**IN THE ENVIRONMENT COURT
AT CHRISTCHURCH
I TE KŌTI TAIAO O AOTEAROA
KI ŌTAUTAHĪ**

Decision No. [2025] NZEnvC 205

ERRATUM

Connell Terrace Structure Plan

Connell Terrace Structure Plan

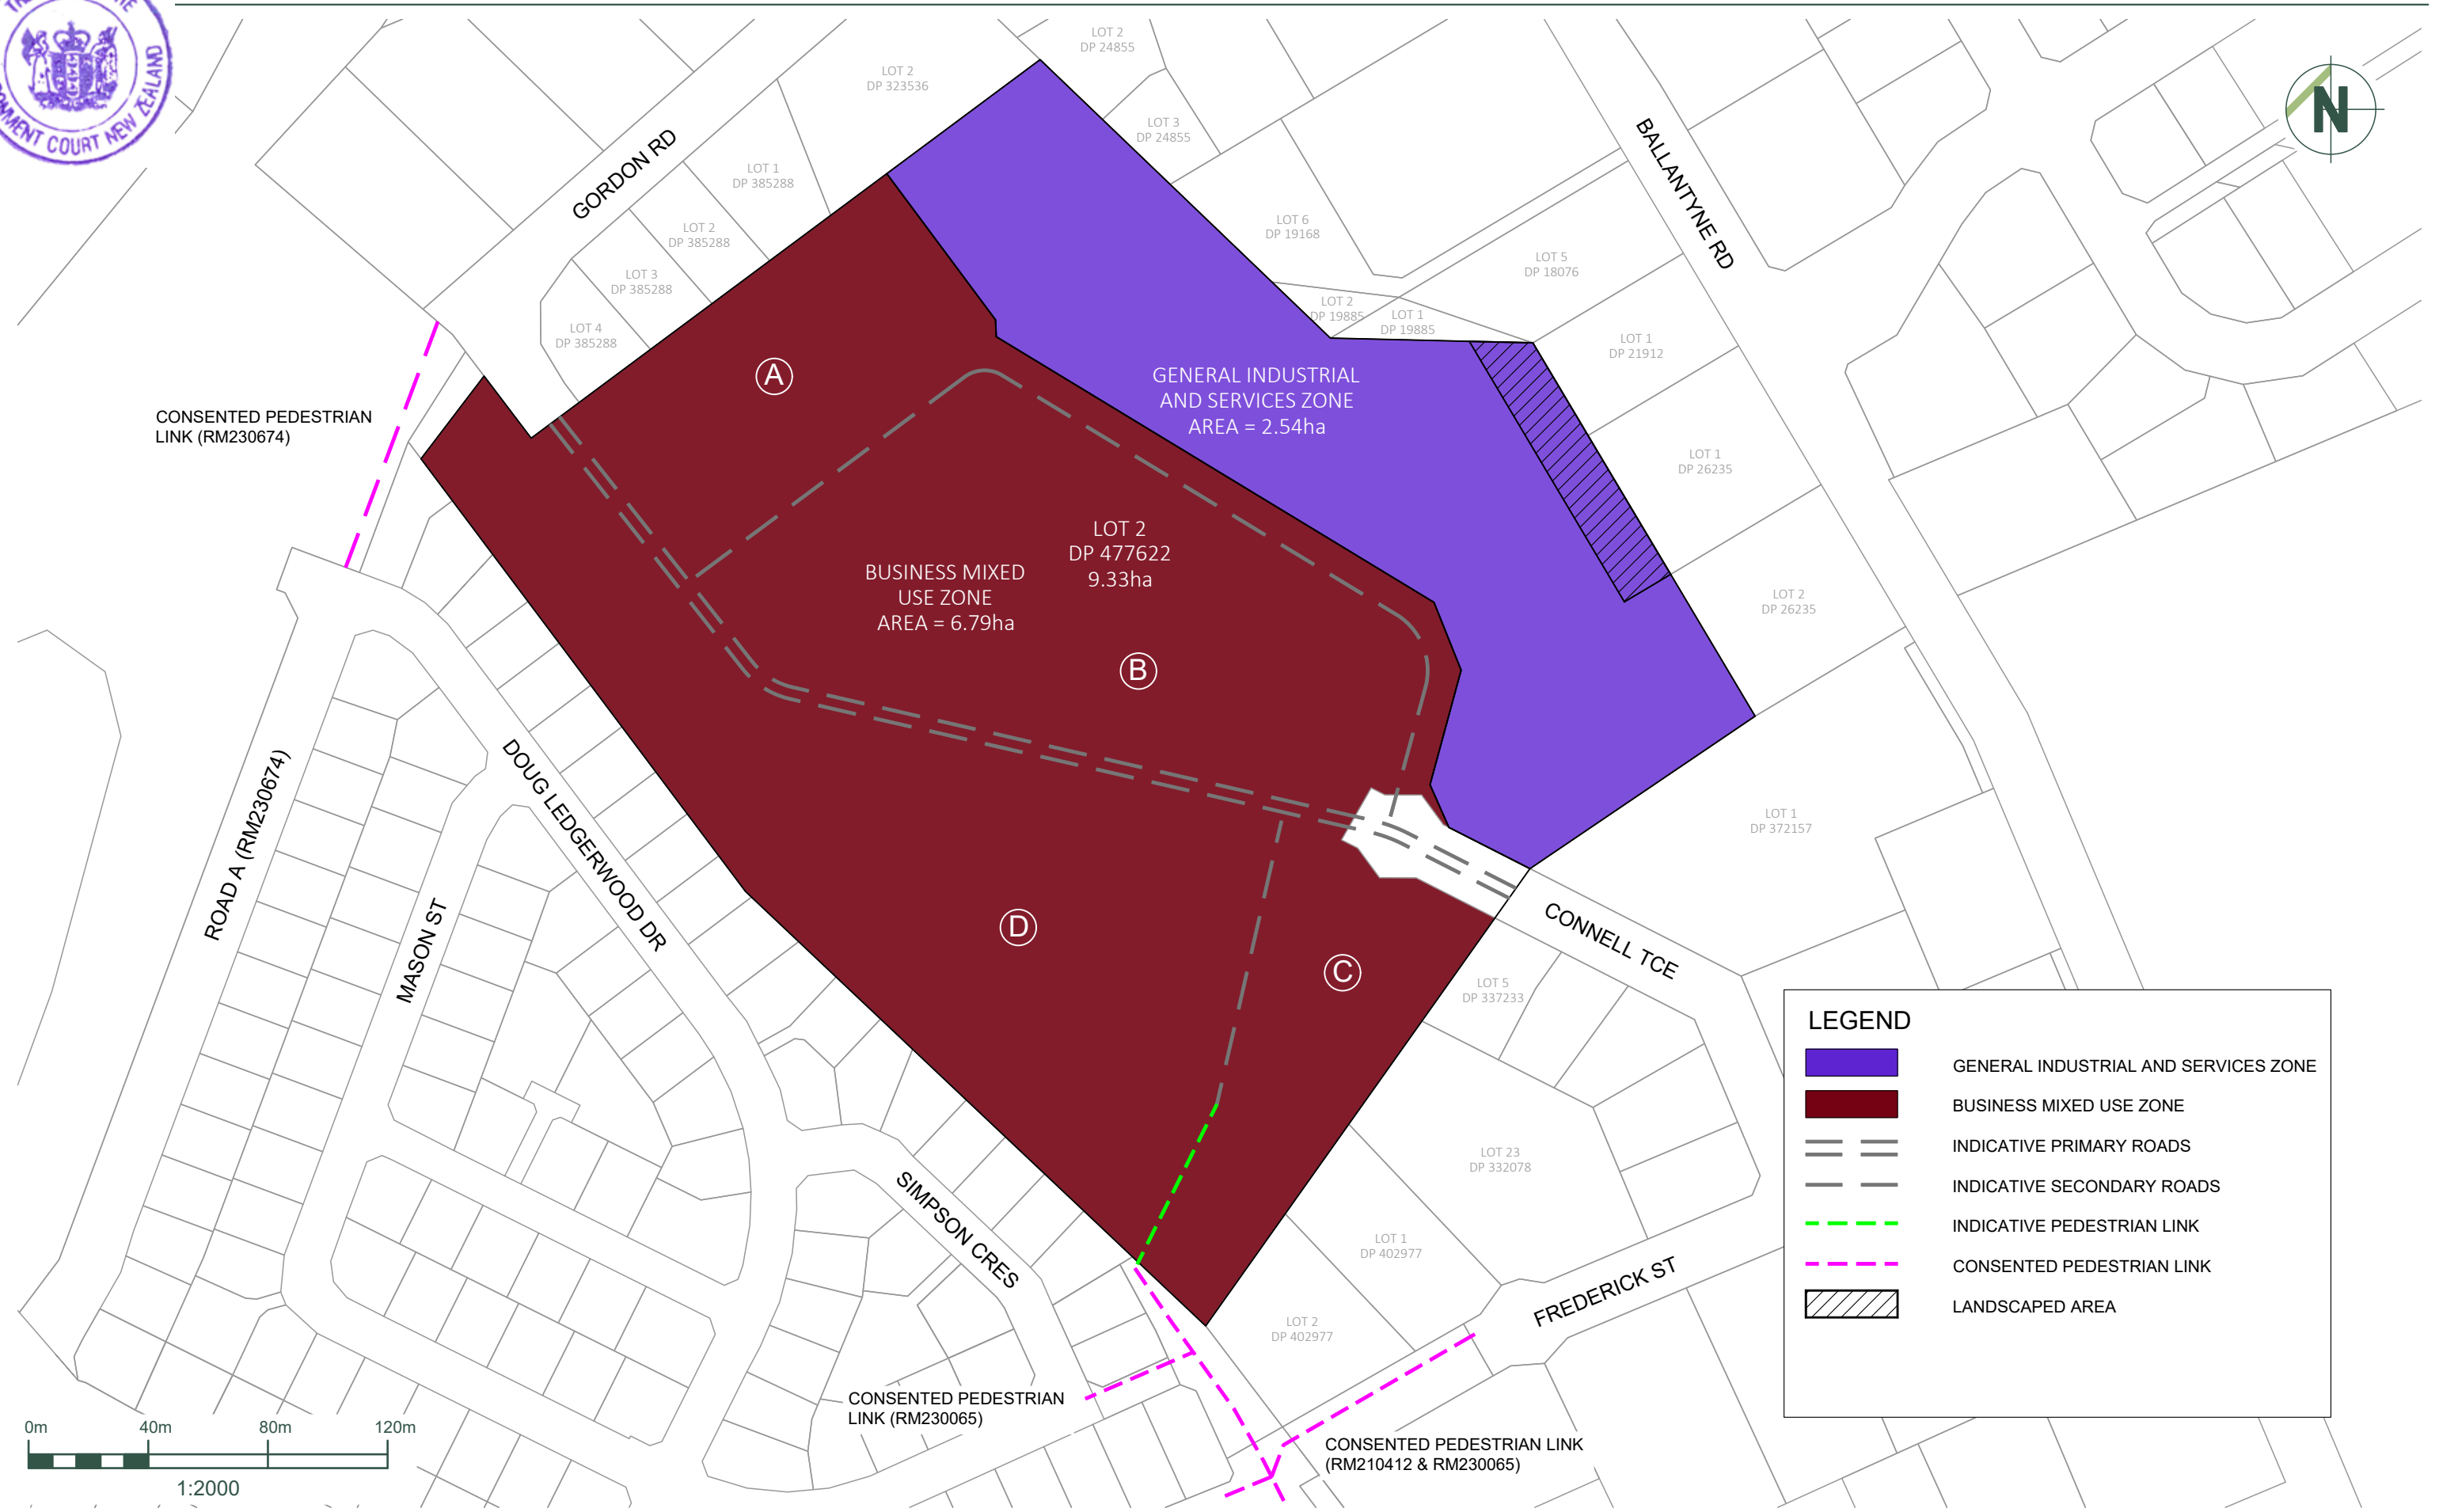
AND

QUEENSTOWN LAKES DISTRICT
COUNCIL

[13] Tussock has now corrected the plan to exclude the cul-de-sac from this zoning. The updated structure plan is attached as Appendix 3.

- 27.1.1.1 Ensure subdivision is consistent with the Connell Terrace Structure Plan by requiring;
- a. landscaping and on-going maintenance of the ~~Building Line Restriction Area~~ Landscaping Area shown on the Connell Terrace Structure Plan; and
 - b. a roading and pedestrian layout that is consistent with the Connell Terrace Structure Plan.
